COMPREHENSIVE GROUND WATER MONITORING EVALUATION

EKCO HOUSEWARES, INCORPORATED

OHIO ENVIRONMENTAL PROTECTION AGENCY

MAY 17, 1994

FIGURE 2 WELL LOCATION MAP FOR EKCO HOUSEWARES FACILITY

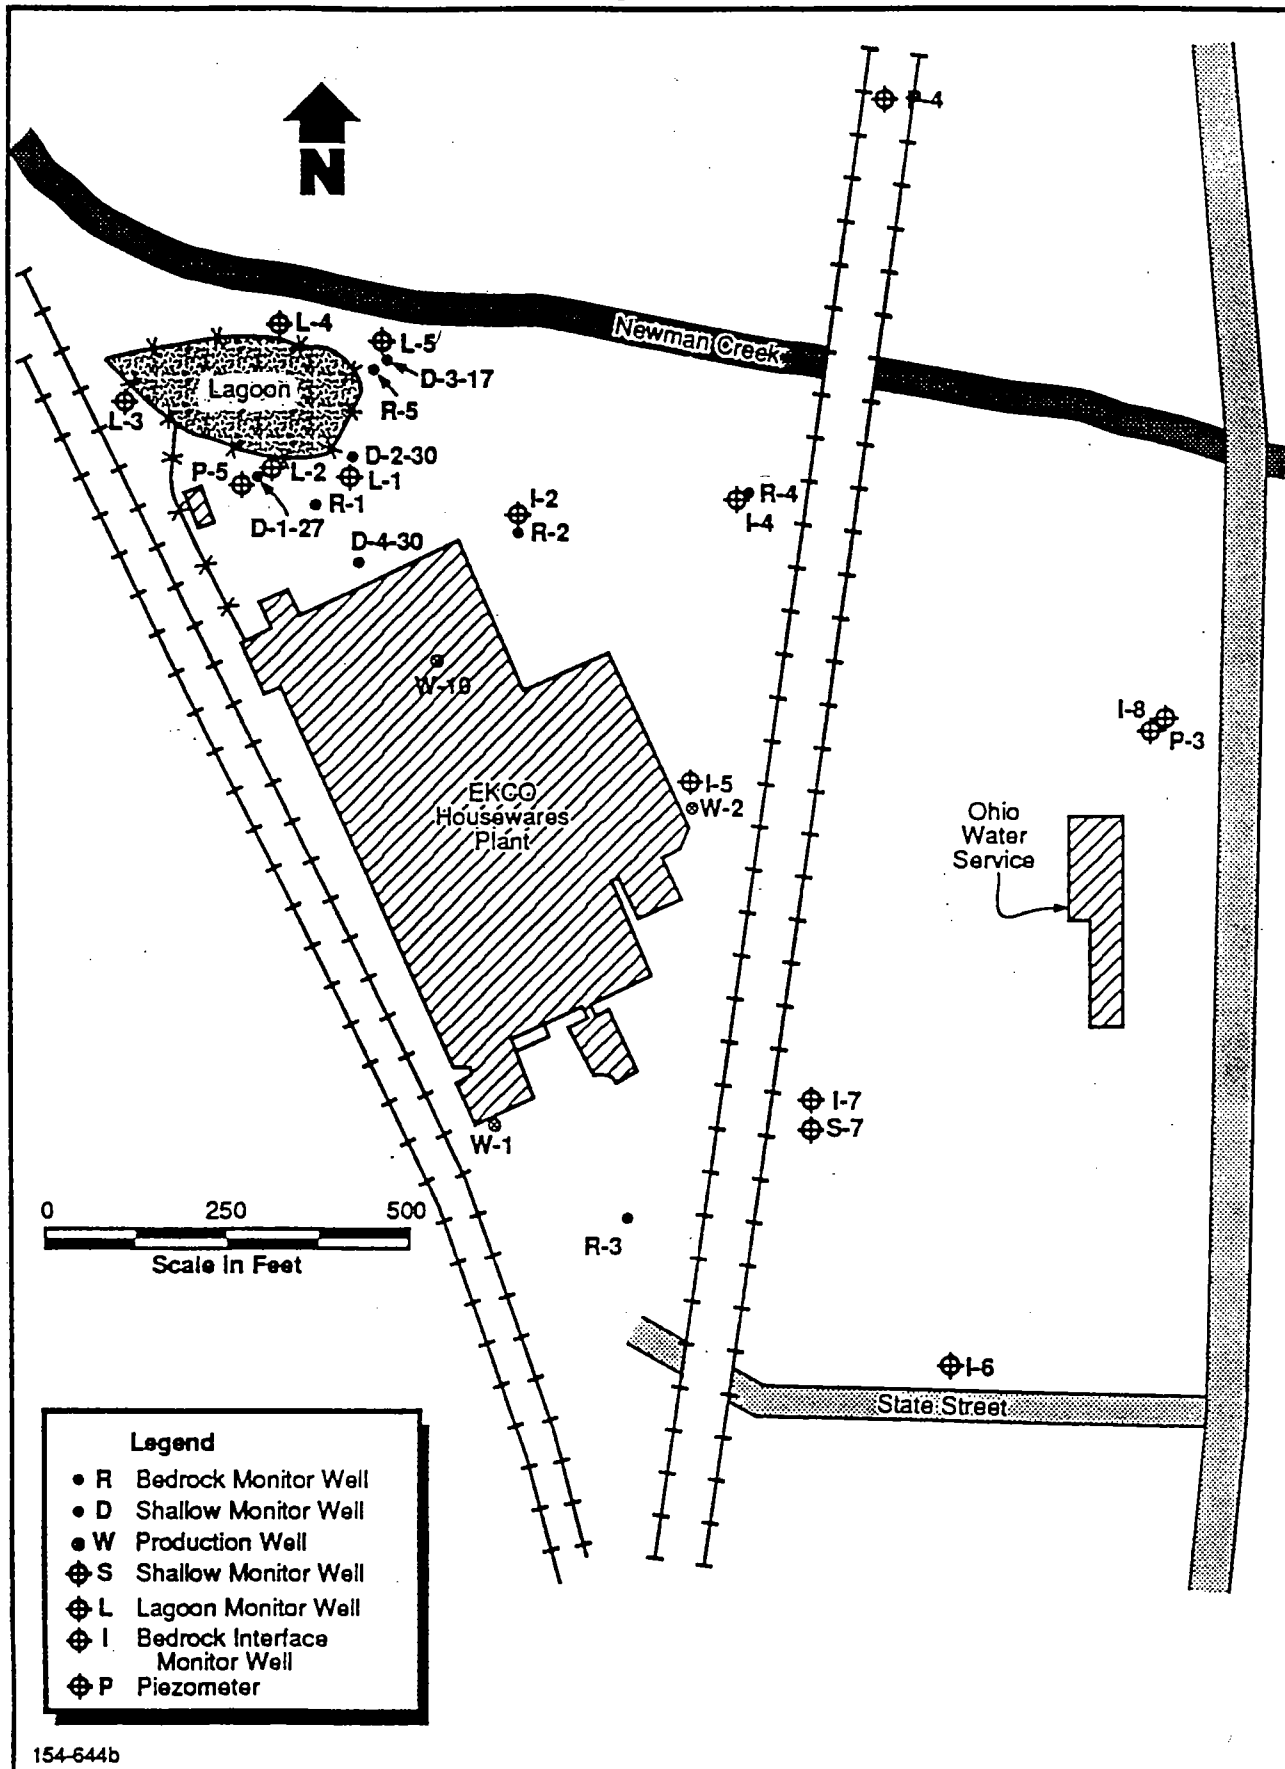
Figure 2 identifies the locations of all wells at the facility. Weston currently samples the L-series wells and R-5 as part of the monitoring network for the surface impoundment. The locations of these wells were verified during the CME inspection. Well L-3 is located upgradient of the impoundment in compliance with Rule 3745-65-91(A)(1) of the OAC. The remaining wells are located downgradient of the impoundment in compliance with Rule 3745-65-91(A)(2) of the OAC.

Figure 3. Potentiometric surface map from February 15, 1994. Contouring by Ohio EPA.

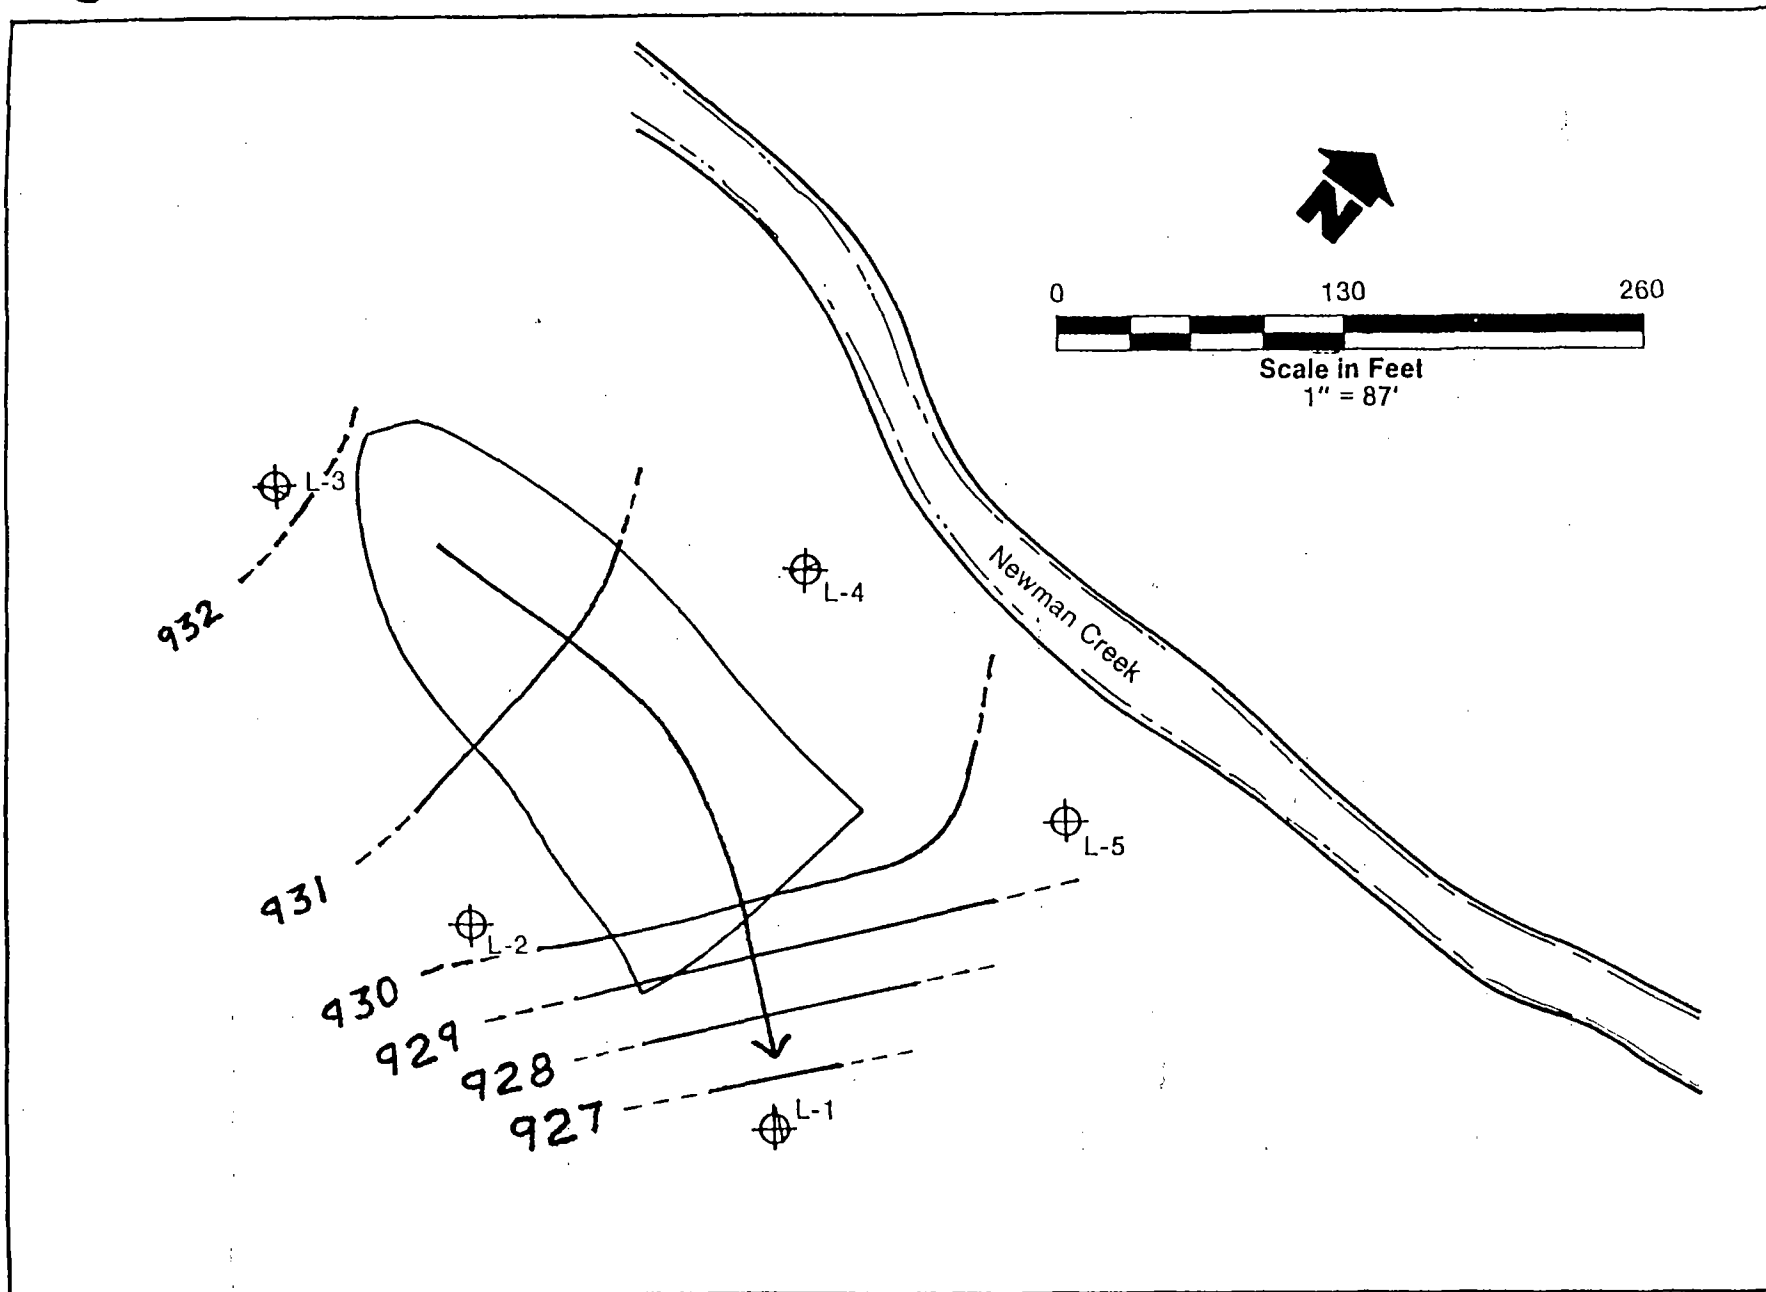
The existing on-site monitoring wells are completed in both bedrock and unconsolidated glacial material (Figure 2). Water levels in the bedrock monitoring wells range from 22 to 52 feet below the ground surface. The water levels in these wells are affected by the pumping of wells W-1 and W-10. The wells near the lagoon are completed in fill and unconsolidated outwash deposits and have a water table closer to the surface. Water levels from these wells occur at approximate depths of 8 to 21 feet below the ground surface. Ground water elevation data obtained during the 1994 CME inspection (Table 1) was used to generate a potentiometric surface map (Figure 3). Ground water entering beneath the lagoon initially travels in an eastward direction but turns southeast prior to passing from below the lagoon. Historical ground water elevation data collected since the last CME is in Appendix B.

FIGURE 3 GROUNDWATER CONTOUR MAP FOR LAGOON WELLS. WATER LEVELS MEASURED 8-10-88.

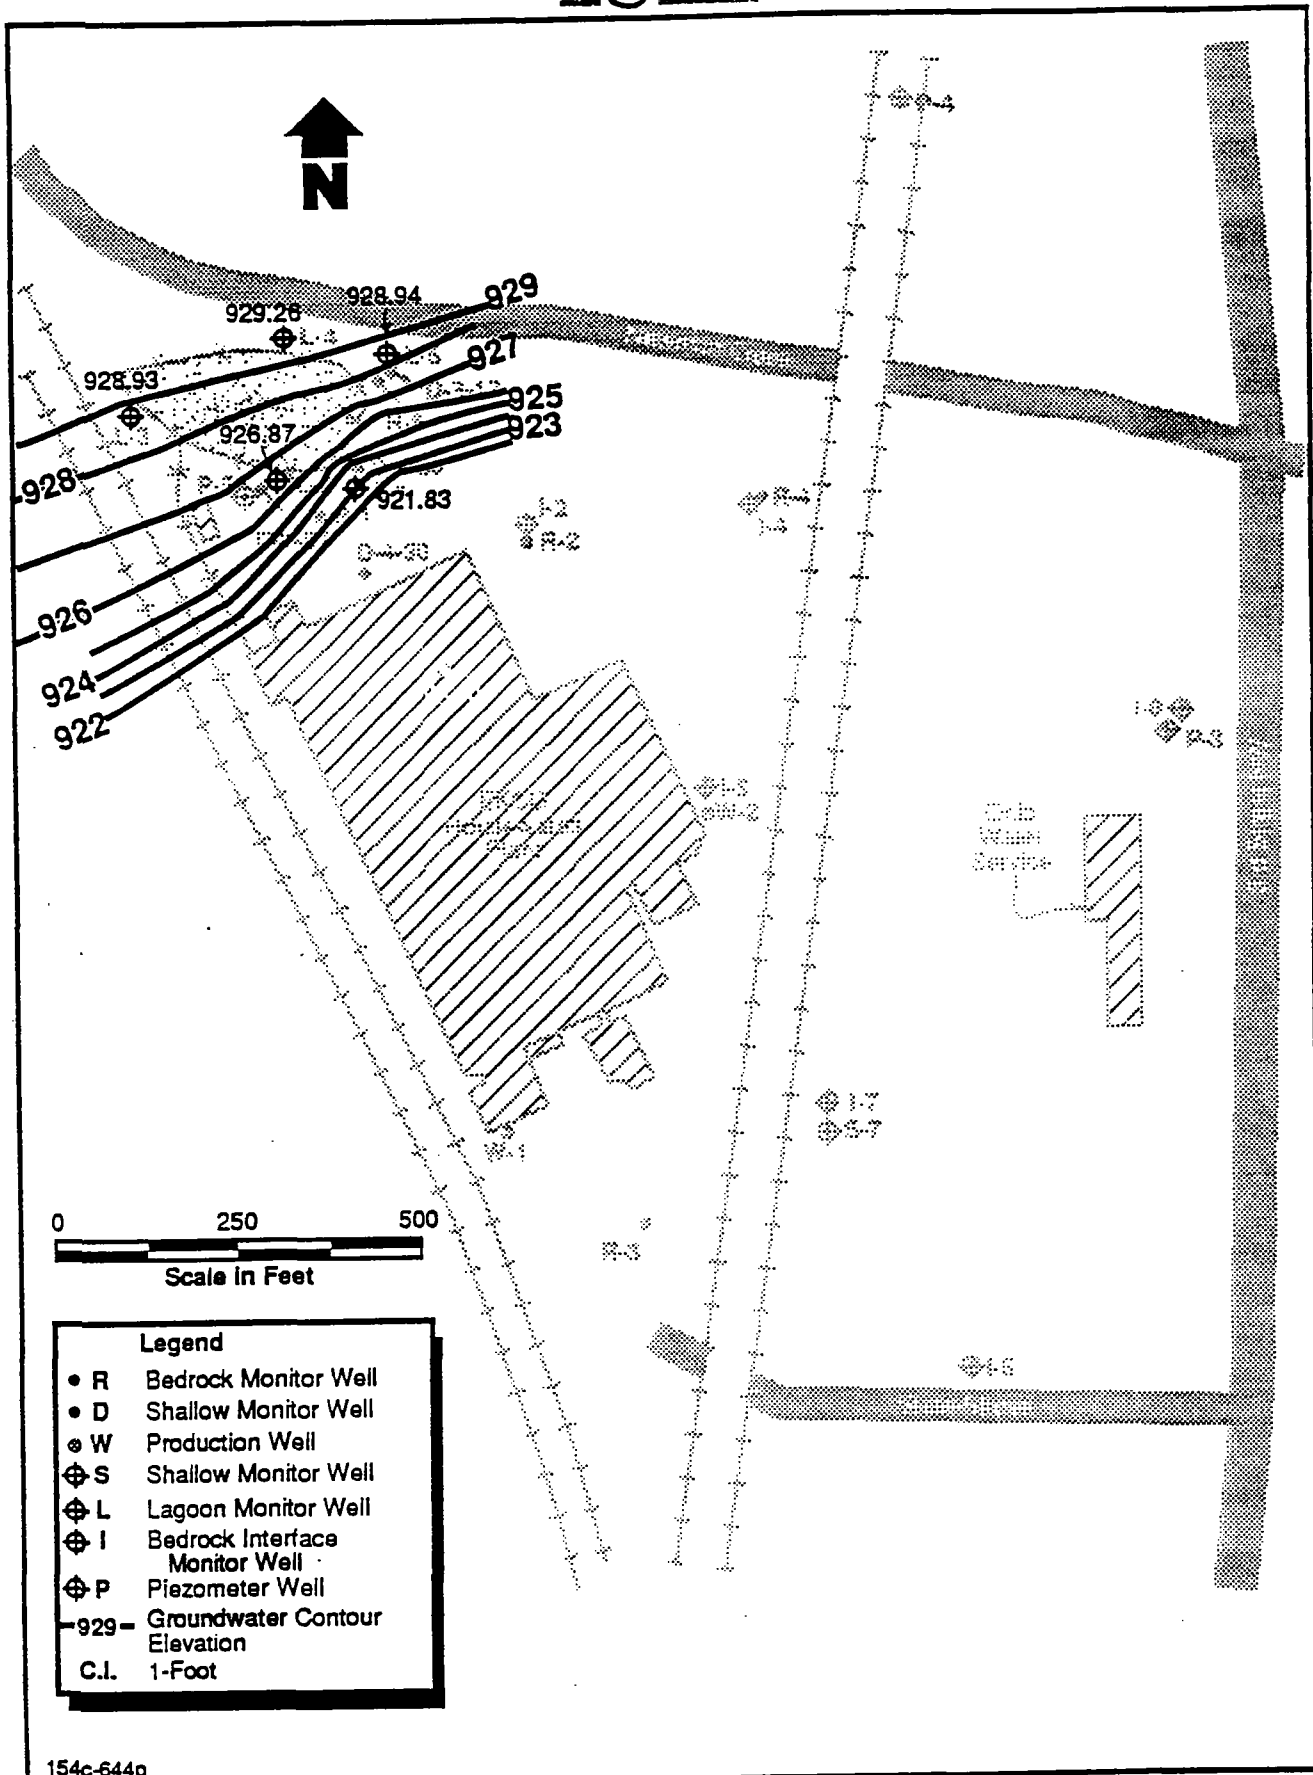
Ground water elevation data from August 10, 1988 was used to generate a potentiometric surface map (Figure 3). Ground water elevation data obtained during the 1991 CME inspection was also used to generate a potentiometric surface map (Figure 4). A comparison of these two figures indicates significant changes in ground water flow direction, possibly due to pumping and non-pumping conditions of nearby water production wells or seasonal fluctuations related to significant amounts of rainfall that fell previous to the CME inspection date. Potentiometric surface maps generated from quarterly data obtained in 1990 also exhibit flow directions that are similar to the August 10, 1988 map, but with some variation.

Figure 4. Ground water flow map for Ekco Homewares, Massillon, Ohio. Water elevations measured on February 7, 1991. Prepared by the Ohio EPA.

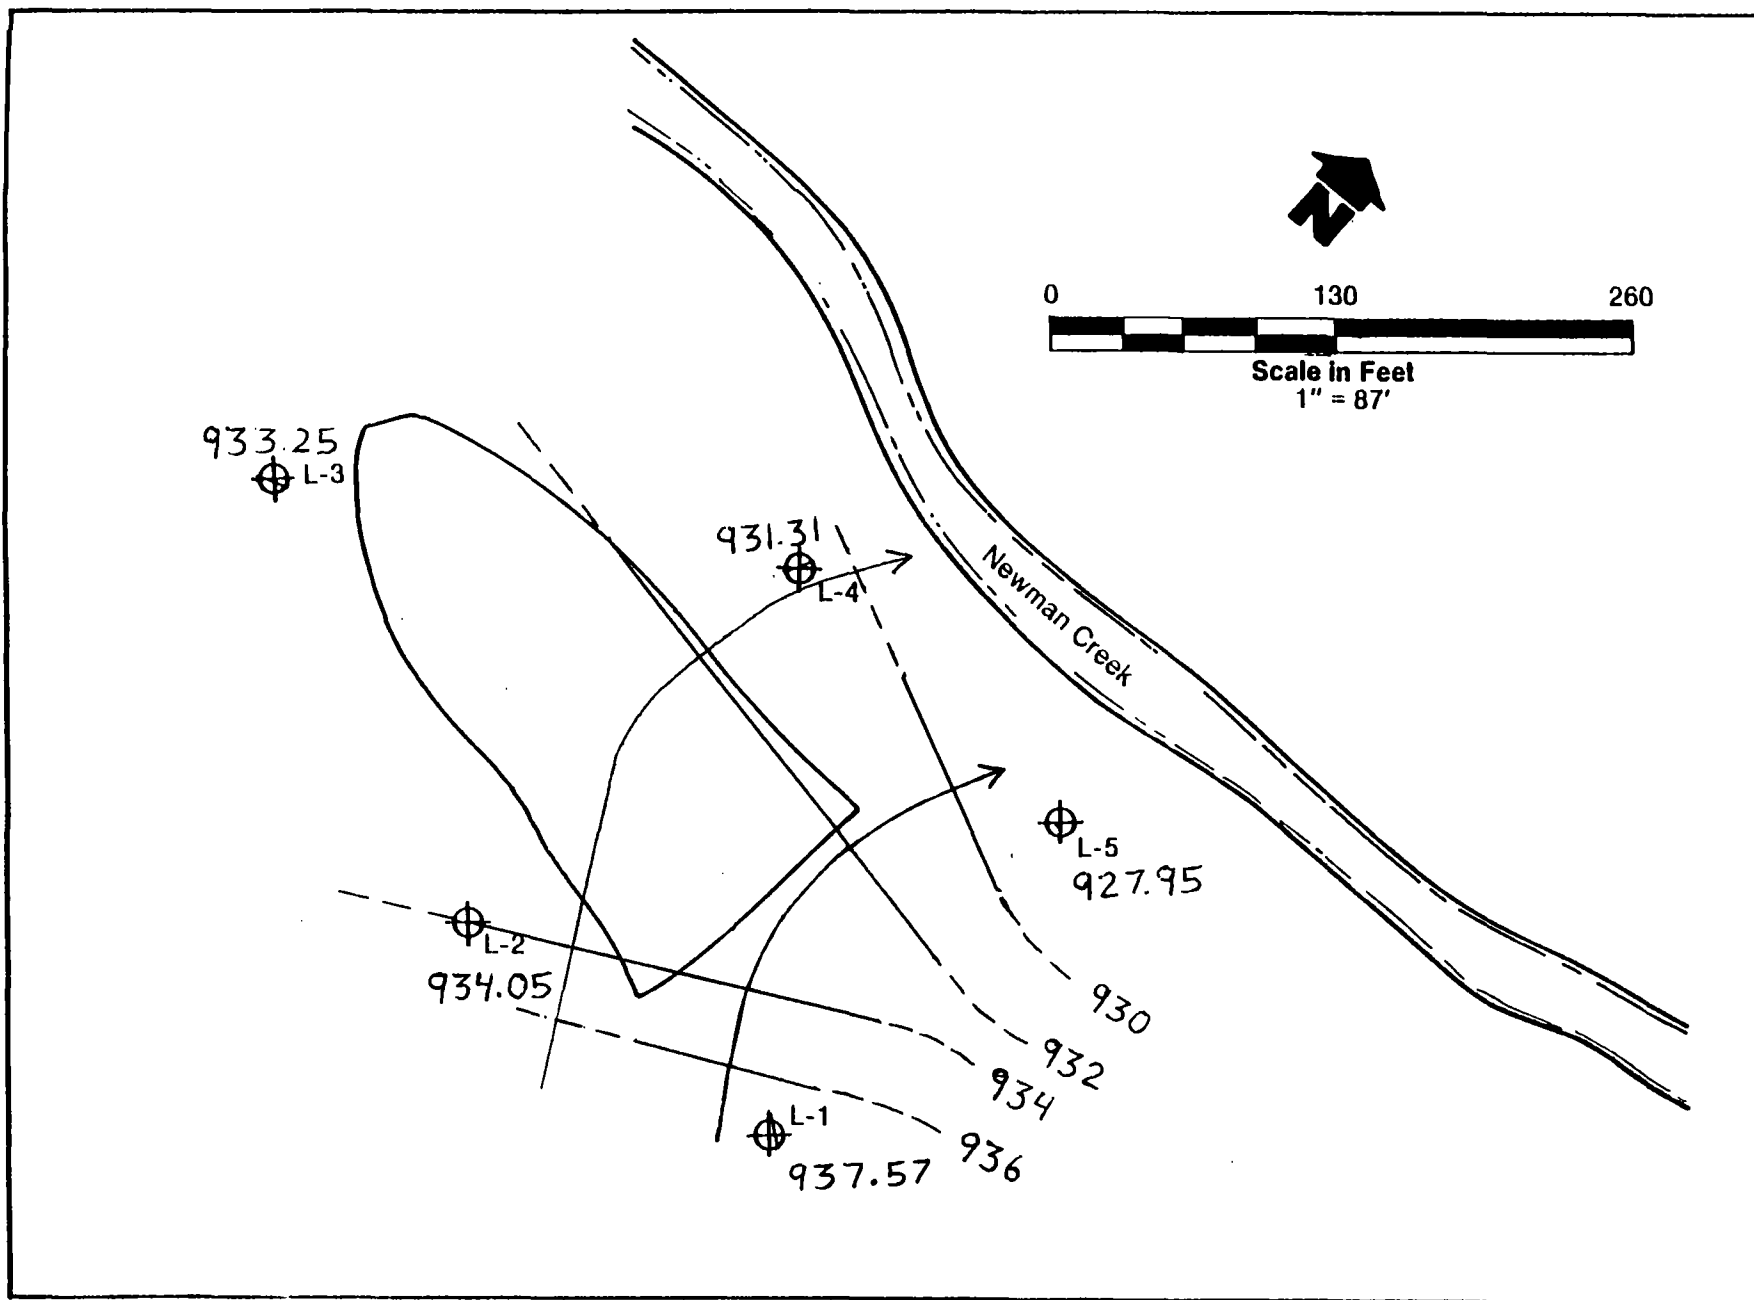
The ground water flow map generated from measurements made during February 1991 suggests that well L-3 may not be located upgradient of the lagoon at all times during the year. The analytical results for future quarters should be examined closely to determine whether ground water contamination detected in well L-3 is due to this change in ground water flow direction.

An evaluation of the rate and extent of migration of contamination should be performed by expanding the assessment monitoring network both vertically and horizontally downgradient of known contamination. This can be accomplished by either drilling new wells and/or using already existing wells on site. The ground water flow direction observed in Figure 4 suggests a need for the installation of a monitoring well across Newman

Creek and located downgradient of the surface impoundment. Additional wells that may be useful in expanding the quarterly assessment monitoring network include wells I-2, R-2, R-4 and I-4. Additionally, the Ground Water Quality Assessment Plan should be modified to indicate what existing and proposed wells will be used in the revised ground water monitoring well network for quarterly analyses.

Deficiency 3. The ground water flow map generated from measurements made during February 1991 suggests that well L-3 may not be located upgradient of the lagoon at all times during the year. Methylene Chloride was detected in this well at concentrations that exceeded the levels observed in trip blanks during February and August, 1990. The analytical results for future quarters should be examined closely to determine whether ground water contamination detected in well L-3 is due to a change in ground water flow direction or laboratory contamination.
